Pines Dining Hall + Servery Addition

Northern Health Authority

Addendum No. 2

DGBK Project No. 17-110

3 REFLECTED CEILING PLAN - PERIMETER PANEL LAYOUT DETAIL
A-302 SCALE 1:10

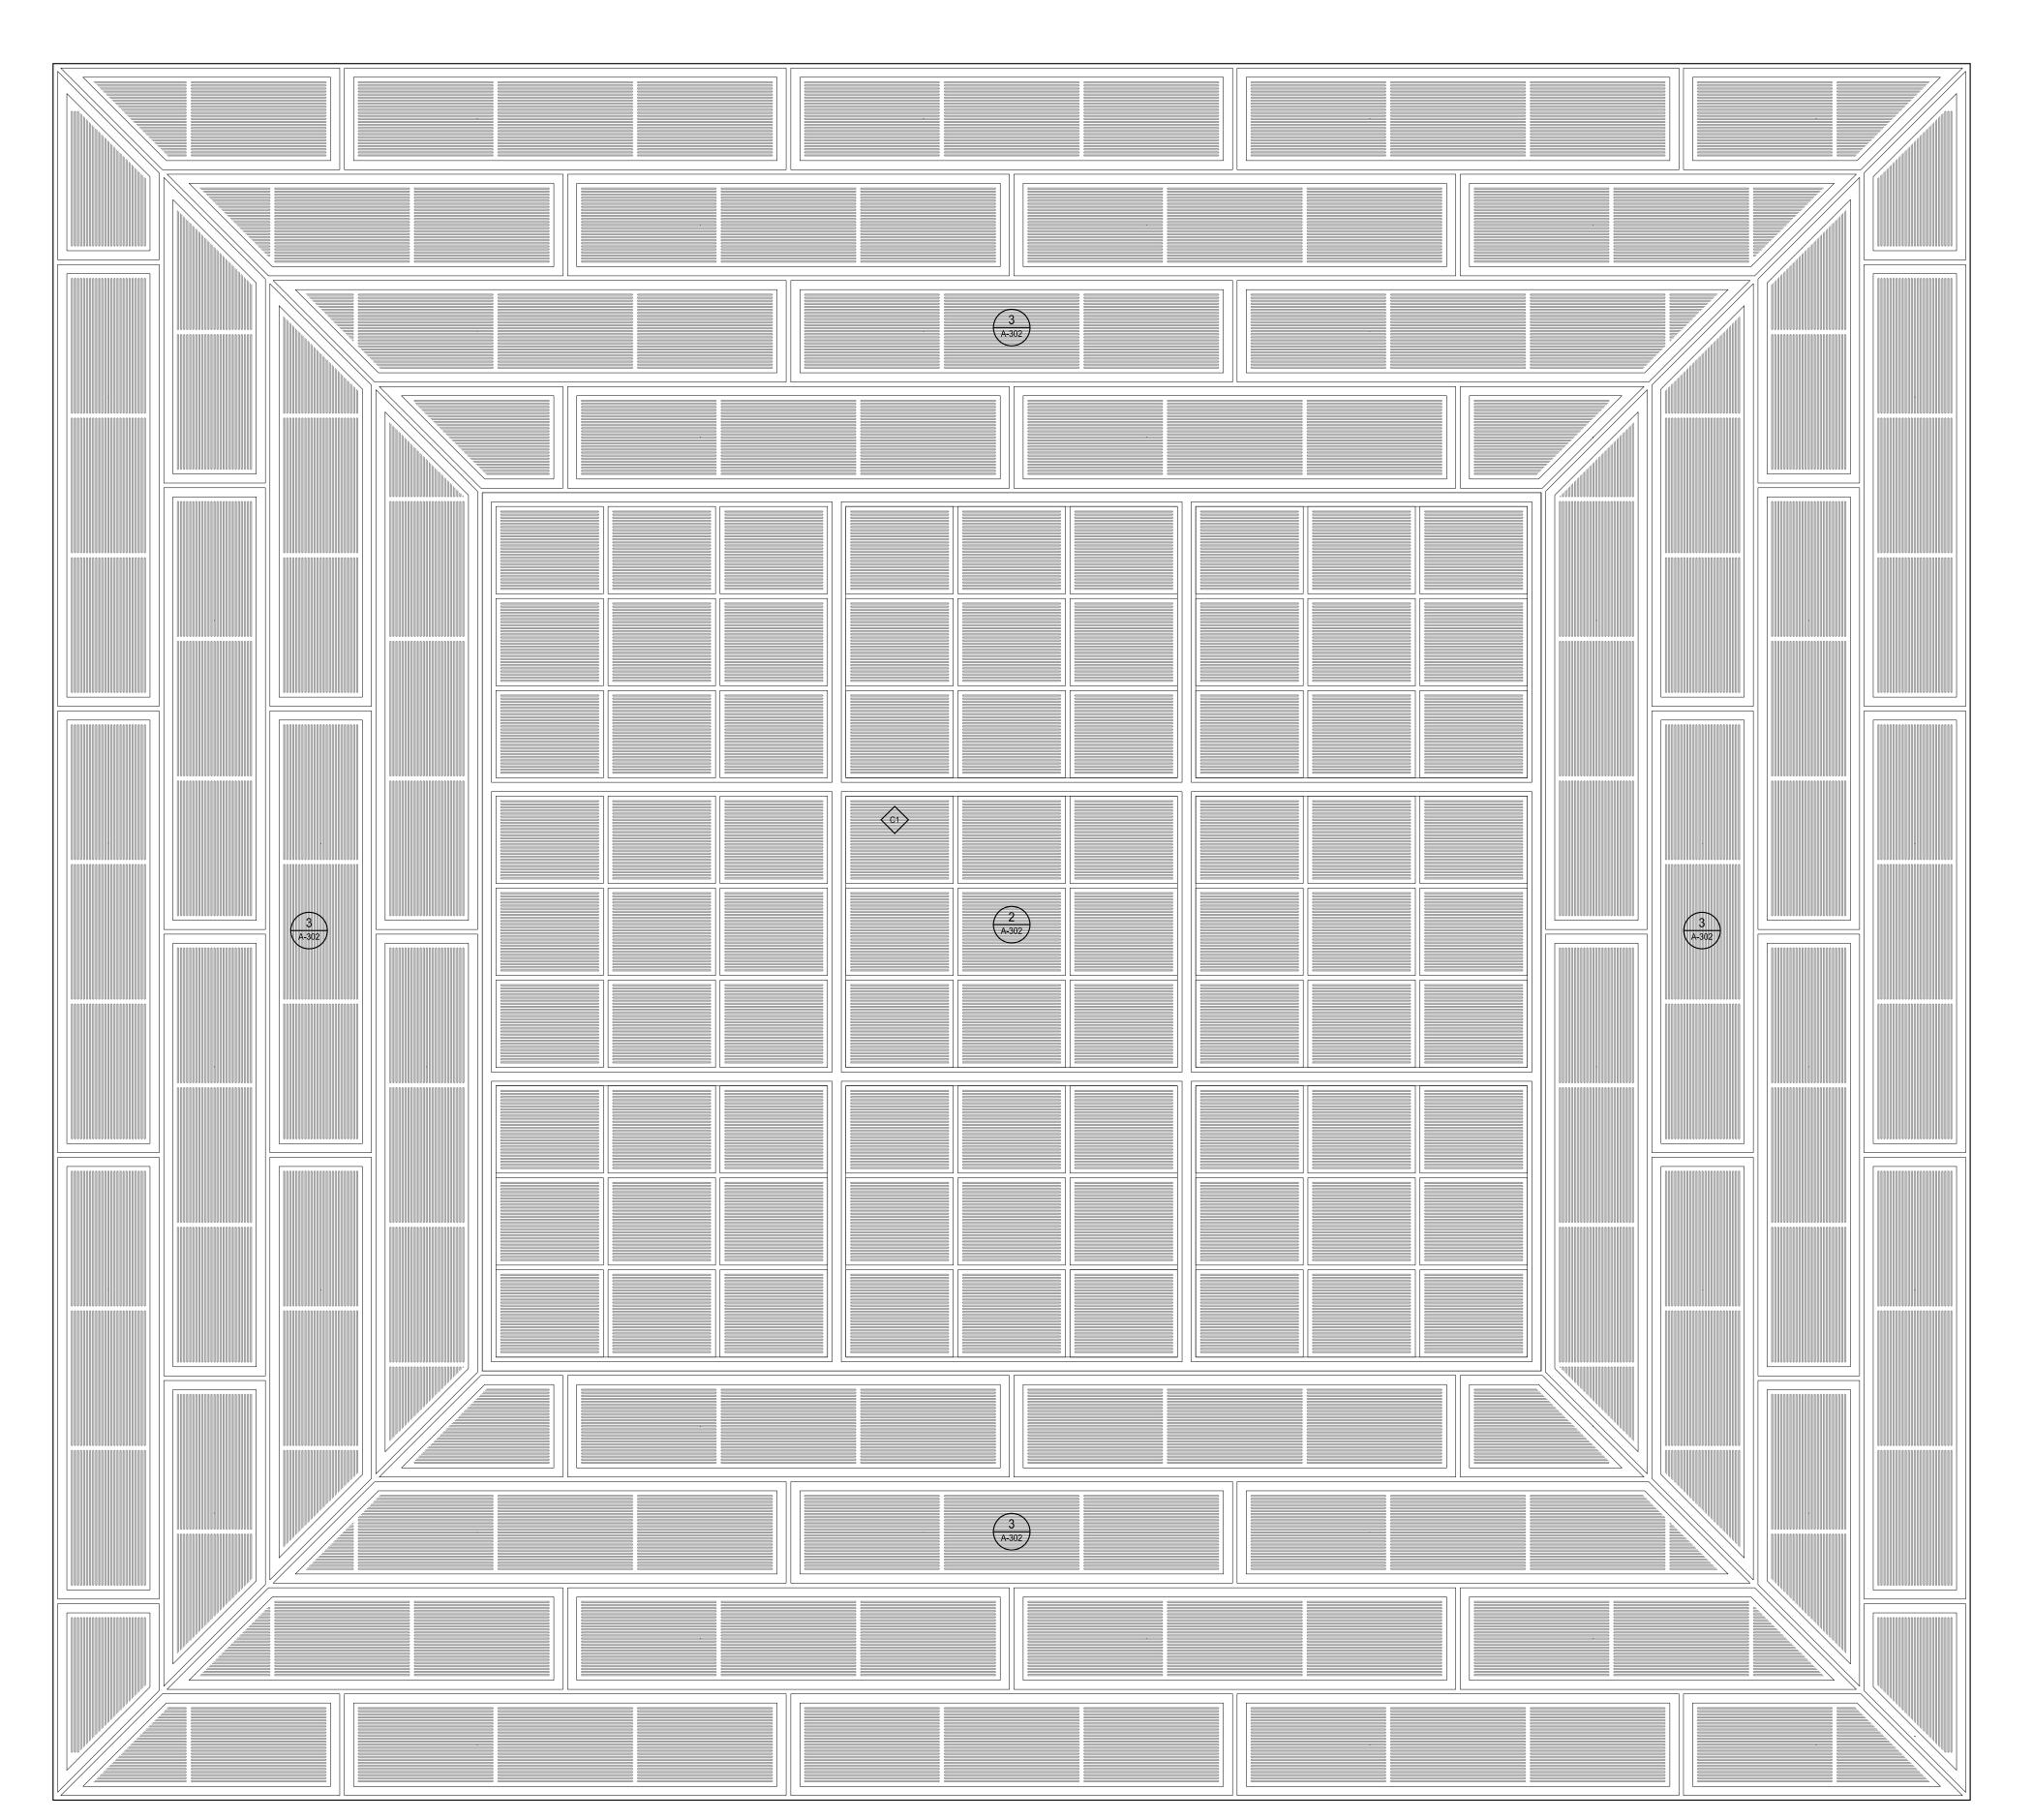
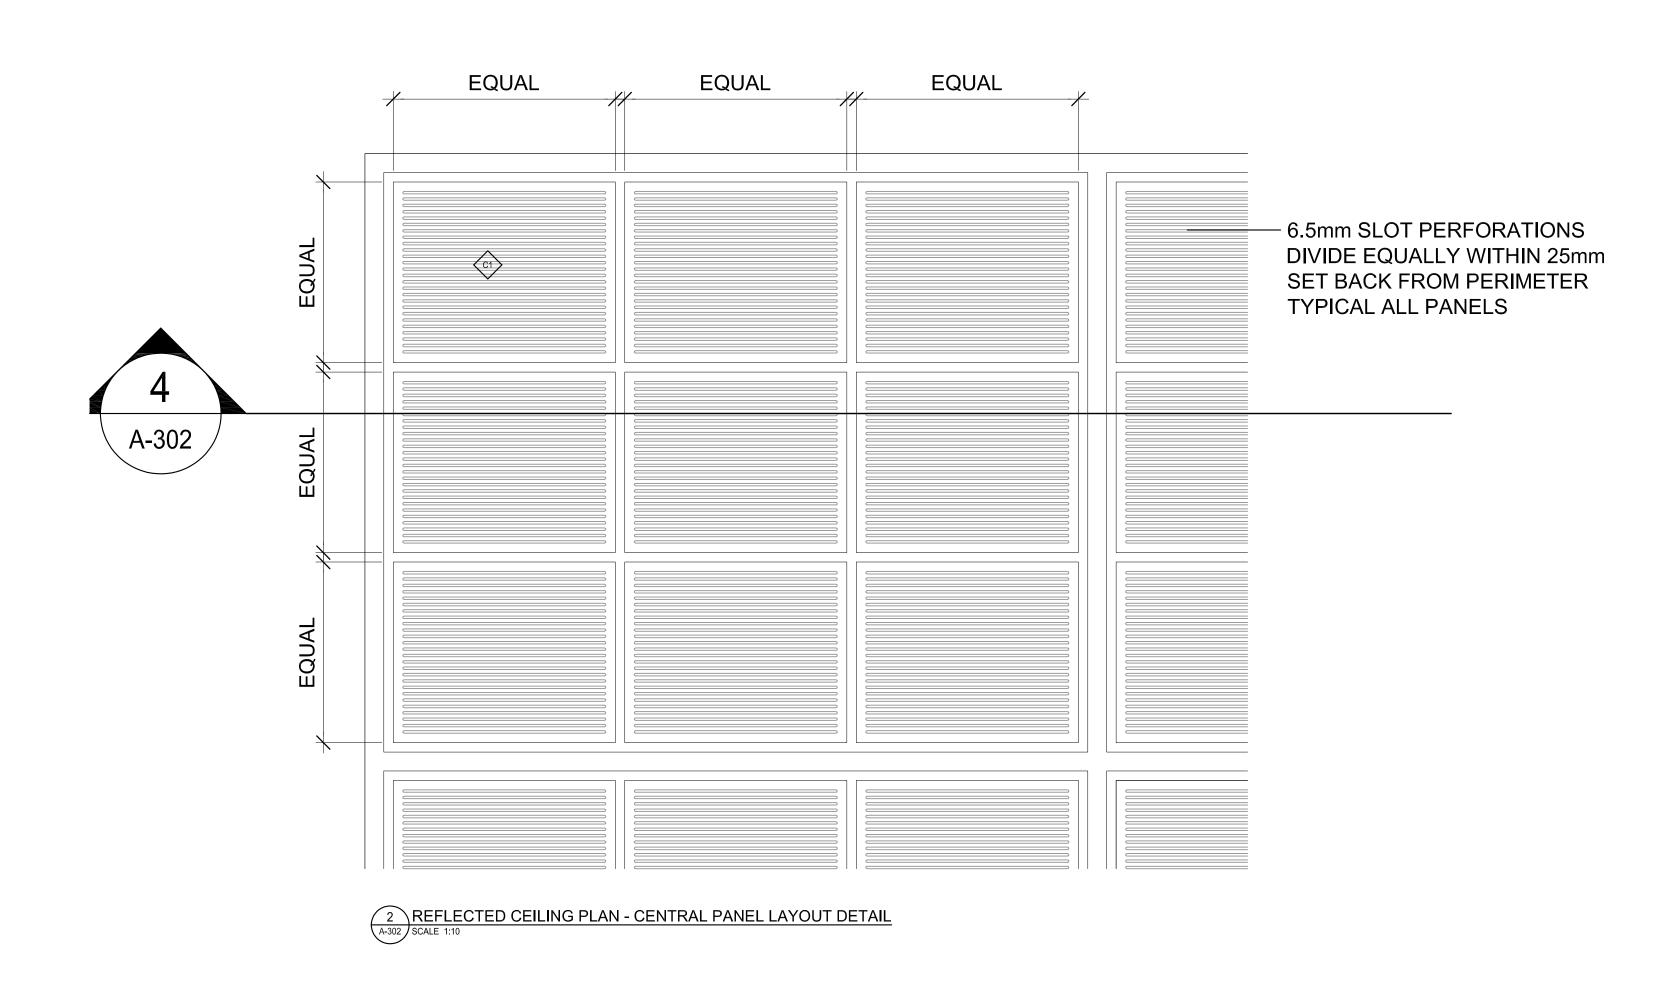
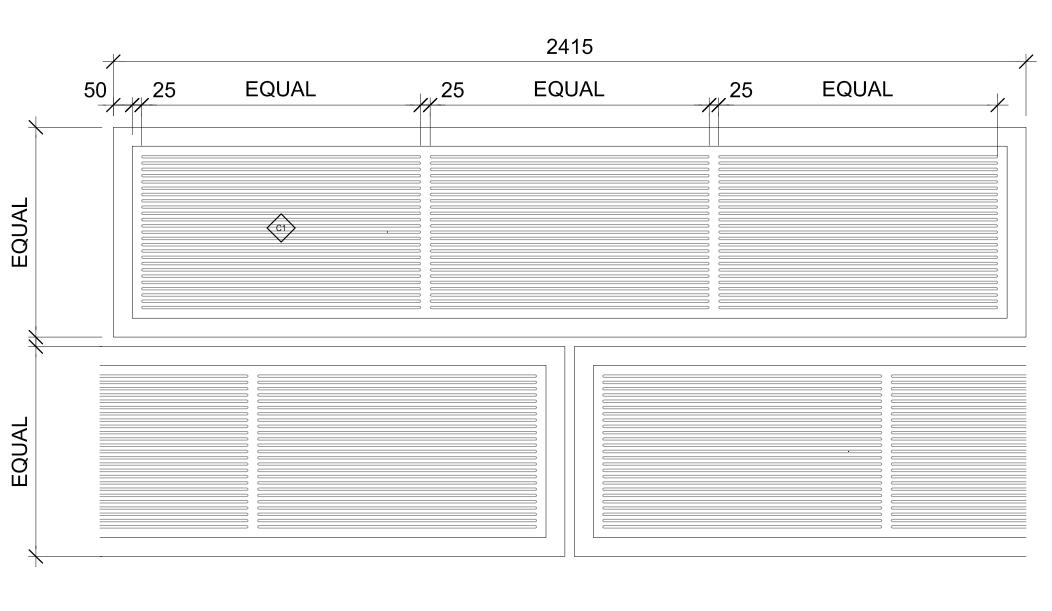
1. Wood Ceiling Panel C-1 – layouts and details.
